Concerns about Woodlawn Park proposed stormwater vault

Beth Kiser

February 22, 2024

Arlington County Forestry and Natural Resources Commission

Appendix: See Slide 8 of DES Vault Proposal Map, September 2023 (All graphics and annotations by DES)

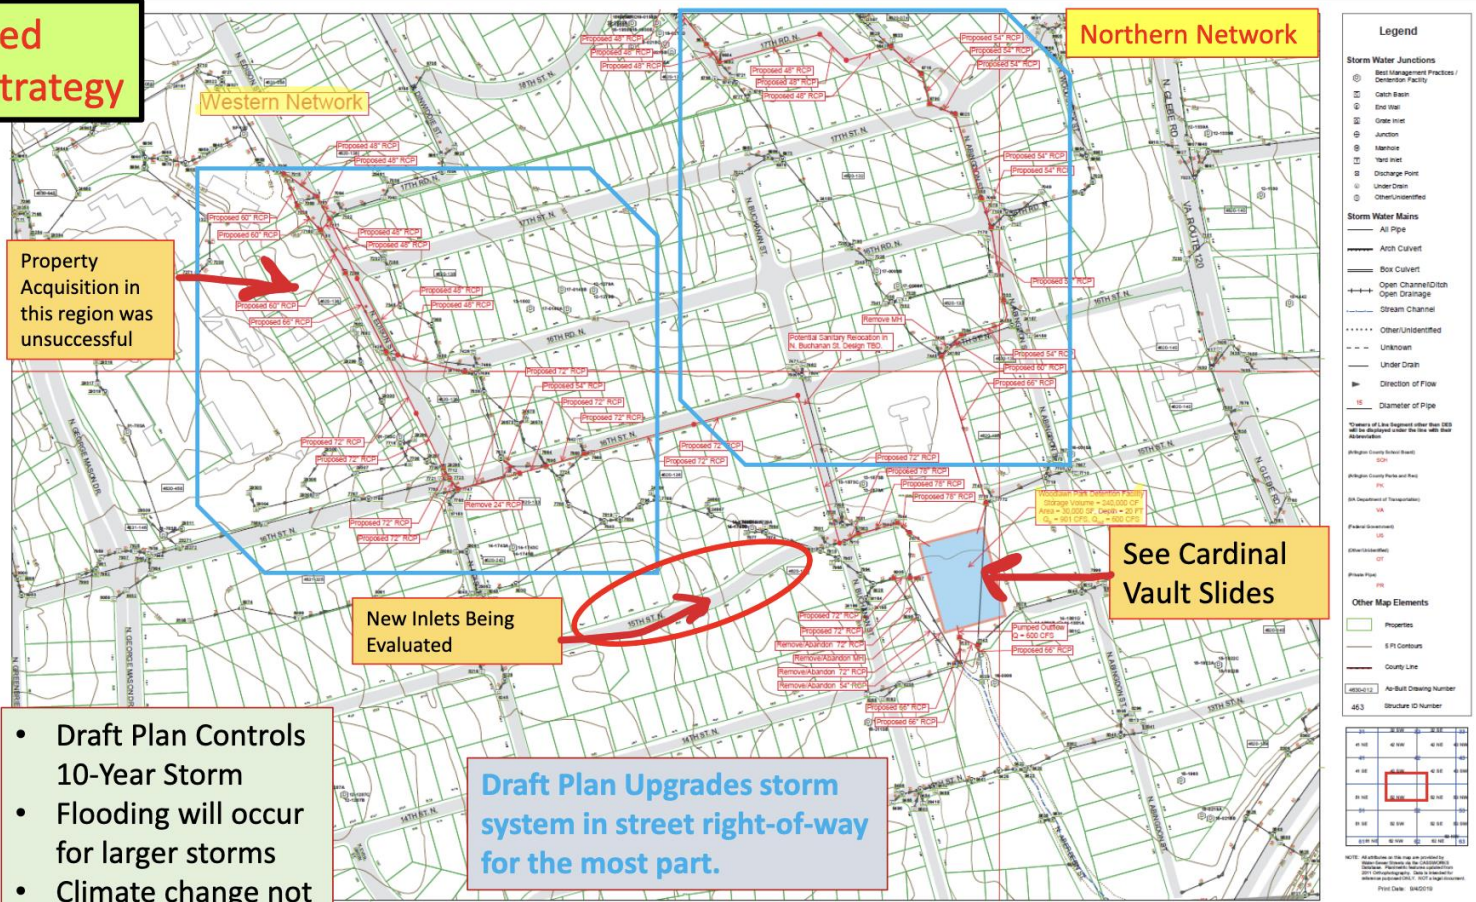
Detention at Woodlawn Park requires Pump & vault is deep.

Concerns regarding utility conflicts along N Edison St.

Property Acquisition in this region was unsuccessful

New Inlets Being Evaluated

Draft Plan Upgrades storm system in street right-of-way for the most part.

- Draft Plan Controls 10-Year Storm
- Flooding will occur for larger storms
- Climate change not accounted for.
